SUBJECT: Mendocino County Comprehensive Land Use Plan consistency determination for a two-phase project that would include 1) a new 7,671 sf retail shell building to house a Panda Express drive-thru restaurant and other retail space; and 2) future 5,500 sf retail building within the B1 Airport Compatibility Zone.

REQUEST: Mendocino County Comprehensive Land Use Plan
consistency determination for Panda Express Restaurant
and Other Retail Space

RE: Application # 18-3591 MaUP/MaSDP/Minor Sub-Panda Express
APN 180-080-077; 1230 Airport Park Boulevard, Ukiah, CA
Revised Application

PRELIMINARY SITE PLAN

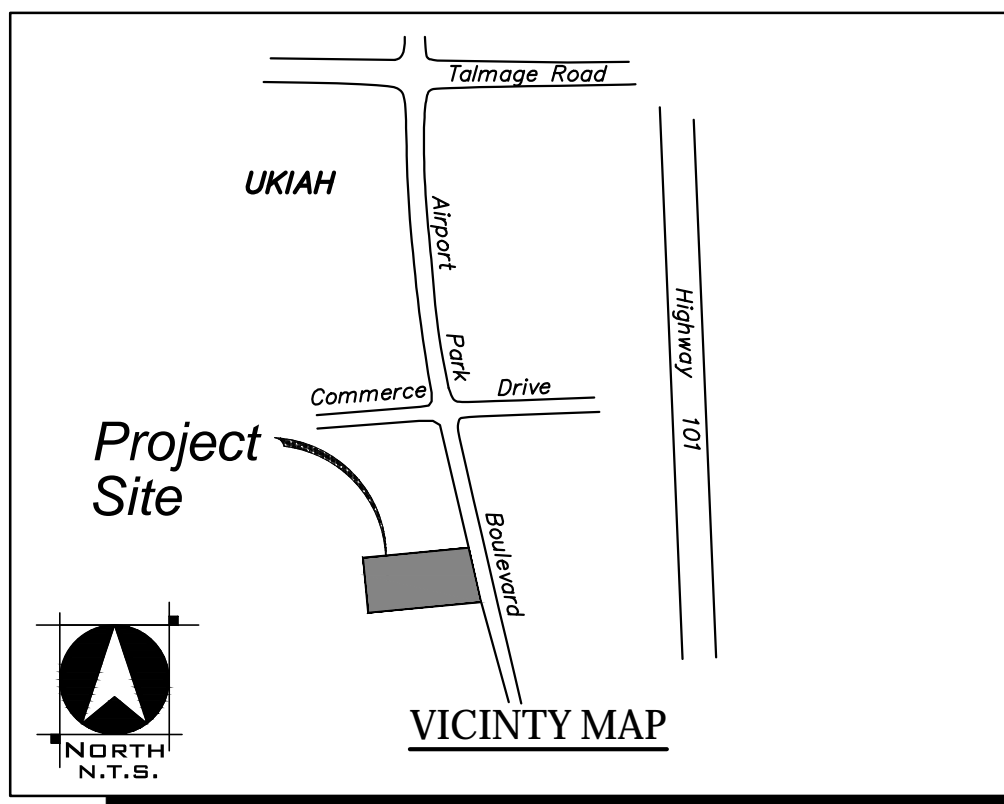
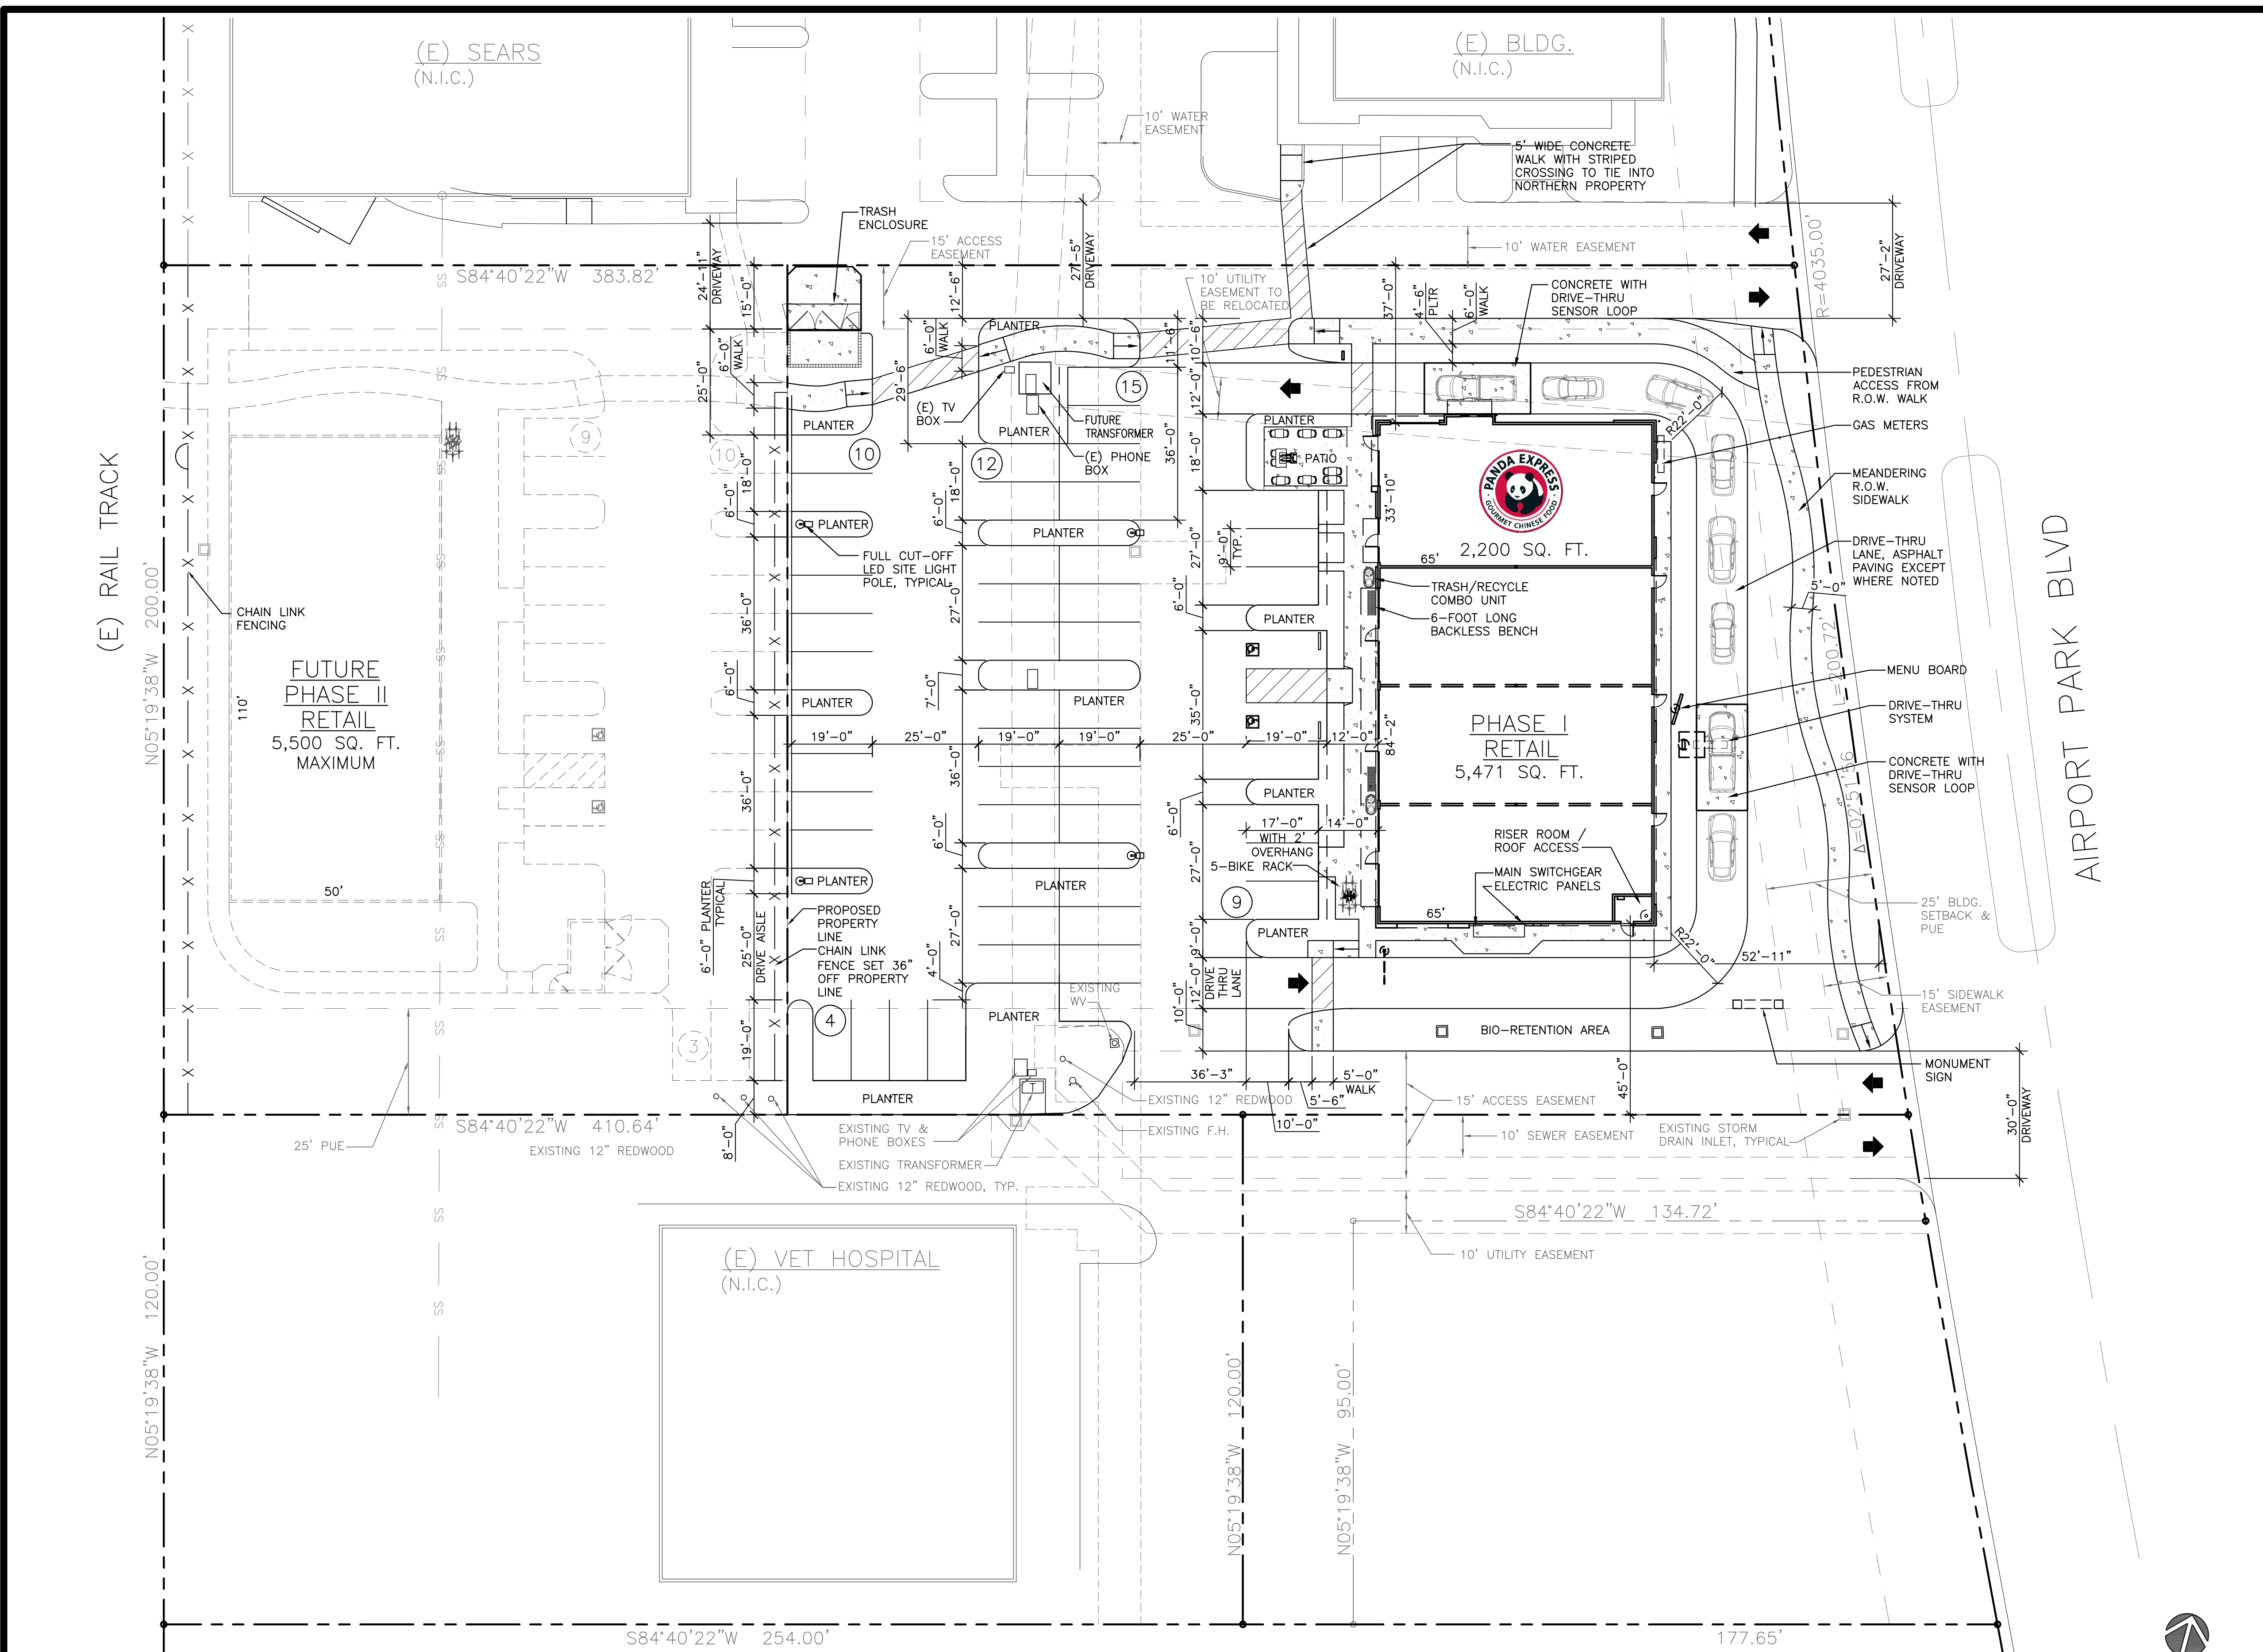
Response: Per the Preliminary Site Plan, Sheet 1, we have designed the continuous 6-foot wide pedestrian walkway along the north property line for access from Airport Park Boulevard to the west property line. We have shown Phase II parcel development intentions. We will not, however, also include a 22-foot easement along the north parcel line or a 15-foot

12. The conceptual drawings do not show where a utility transformer would/may be located in order to feed the customers Service Panel/Main Switch Board. The City will need an approximately 7' x 7' space for any substructure to include transformers and junction pedestals.

19. Please provide total square footage of existing and proposed buildings, as well as a calculation for percentage of open land (everything but buildings, including parking lots, landscaping, etc.) for the Panda Express parcel. This information is needed for the ALUC review.

Response: See Sheet 1, Site Plan, for proposed location of new transformer/pad, as well as revised planters over existing junction pedestals.

Response: See Sheet 1, Site Plan, for proposed location of new transformer/pad, as well as revised planters over existing junction pedestals.

Response: See Sheet 1, Site Plan, under Project Data, for building area and open area calculations of both phases of project.

TENTATIVE PARCEL MAP PANDA EXPRESS & RETAIL CENTER

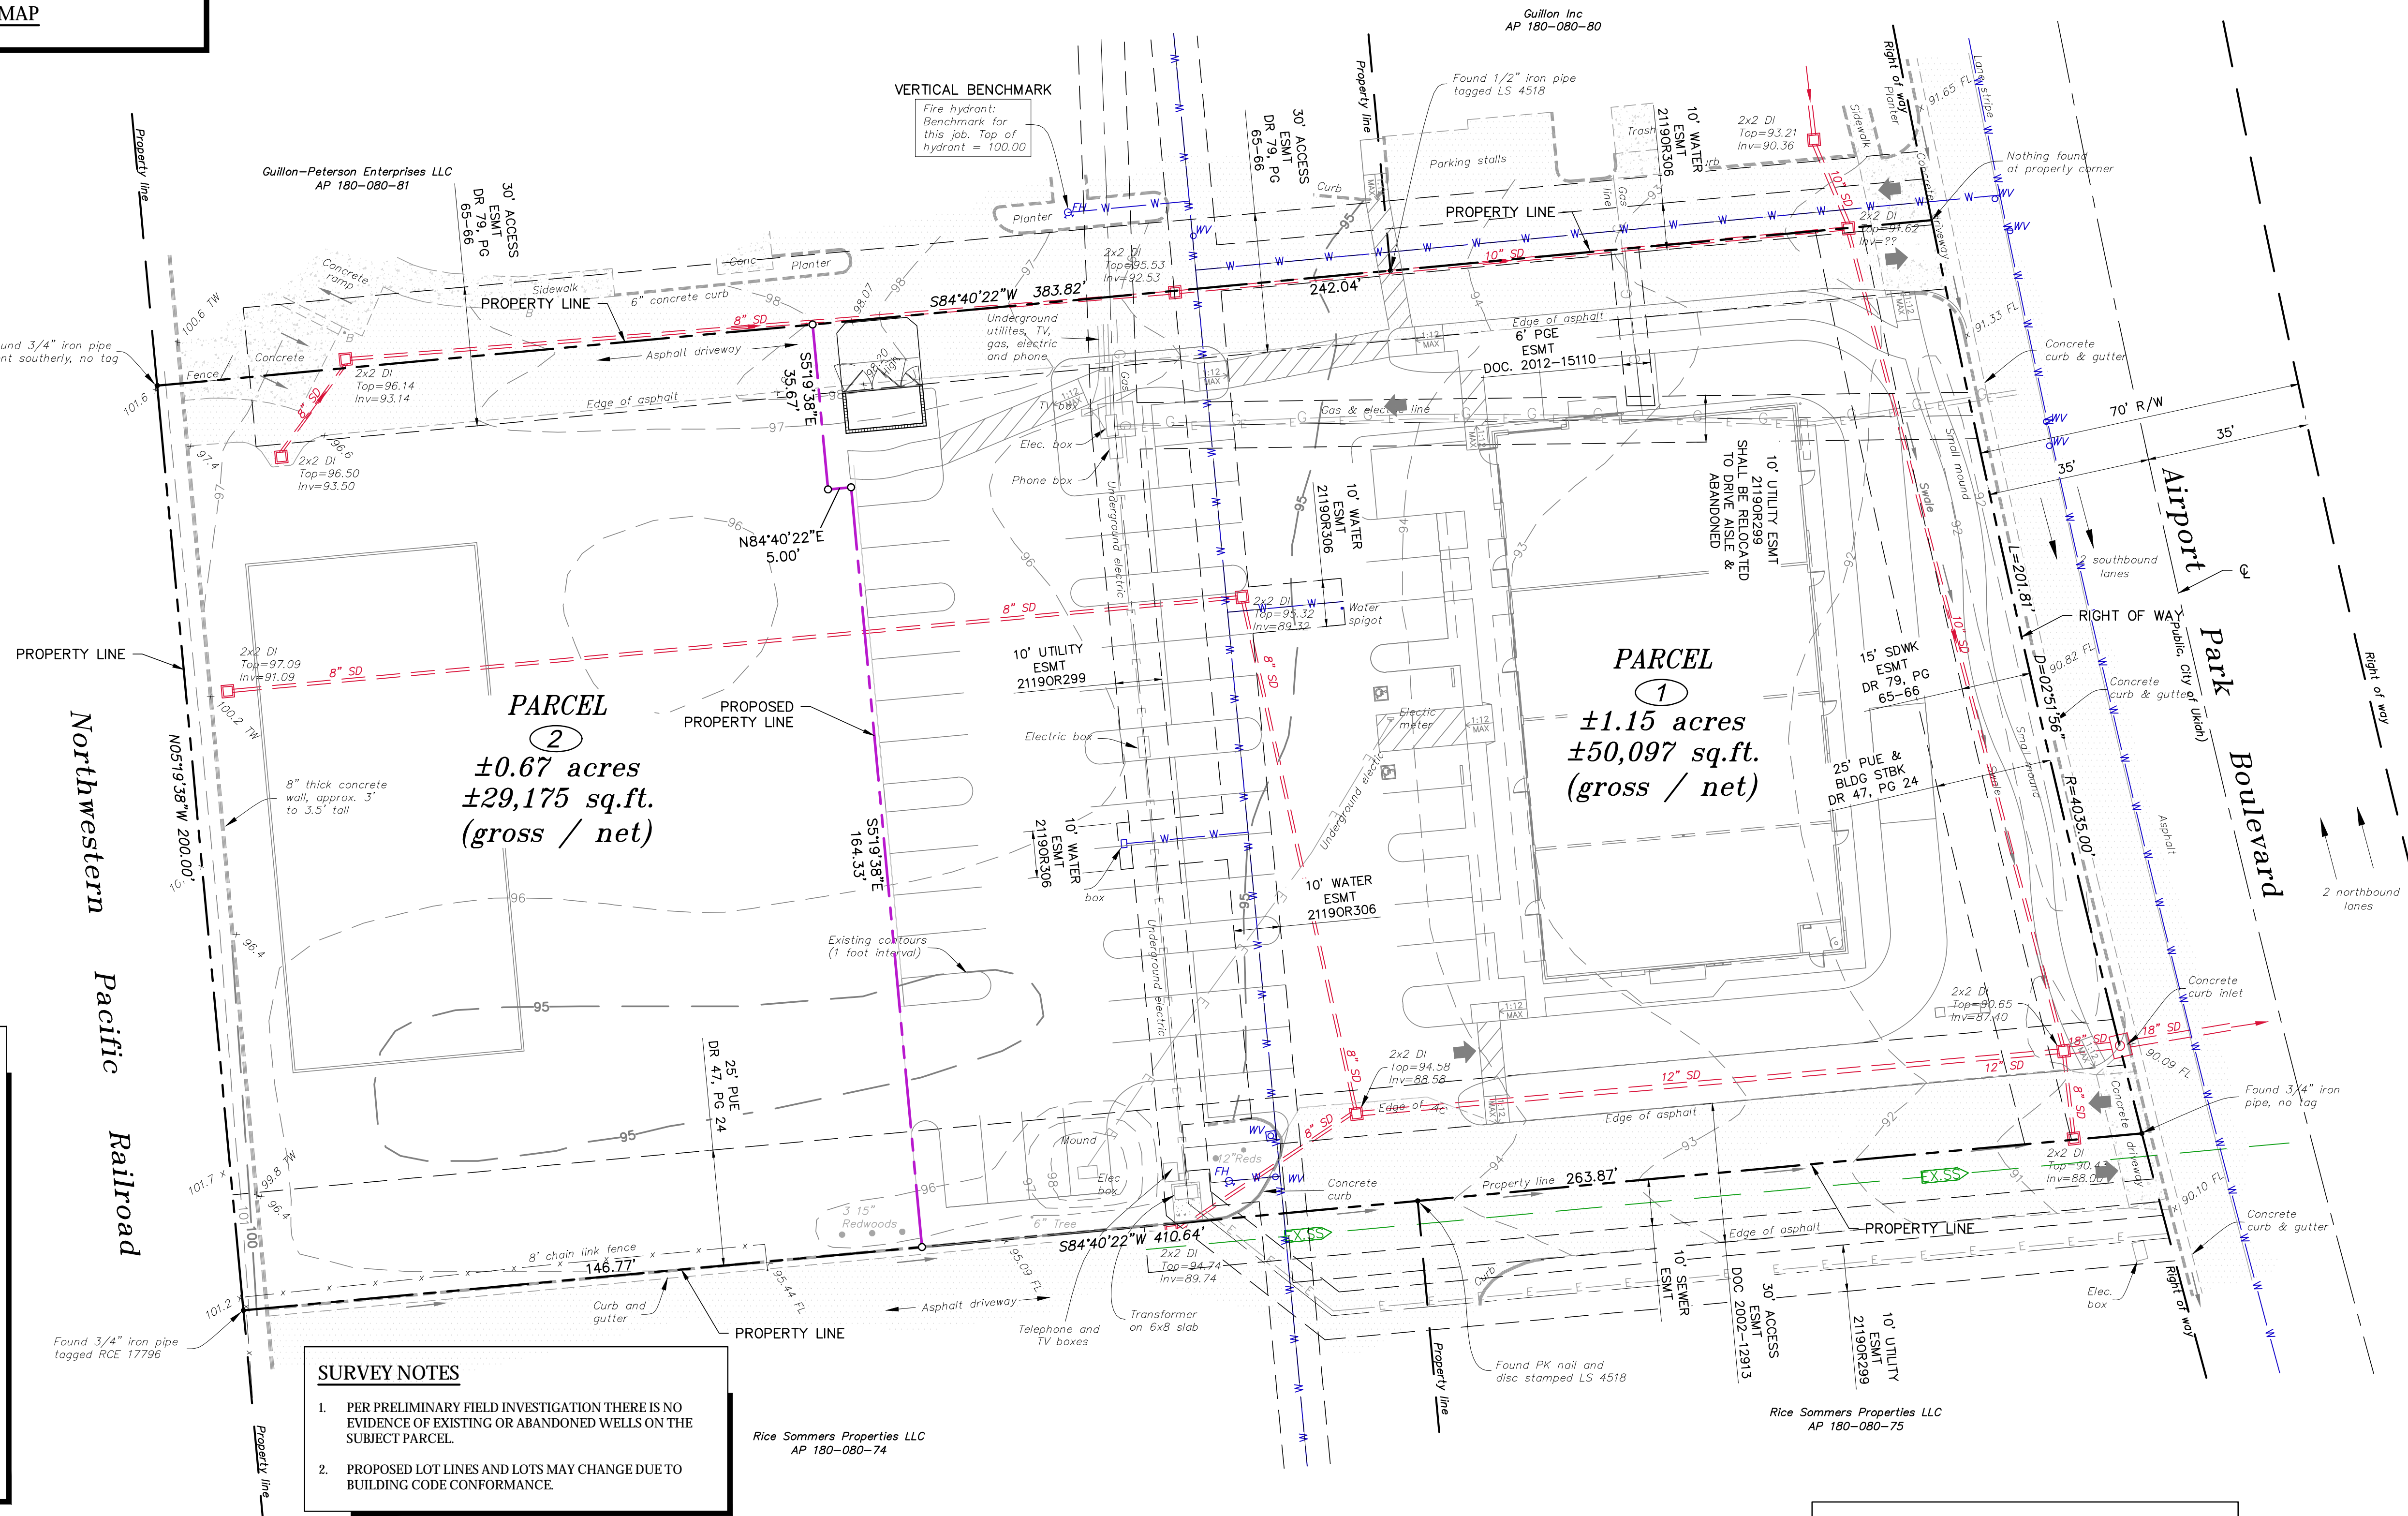
4. On the tentative map, indicate both gross and net areas for each parcel.

Response: The gross and net areas are equal for this site, which is now indicated on the tentative map. (See Sheet TPM-1 – Tentative Parcel Map)
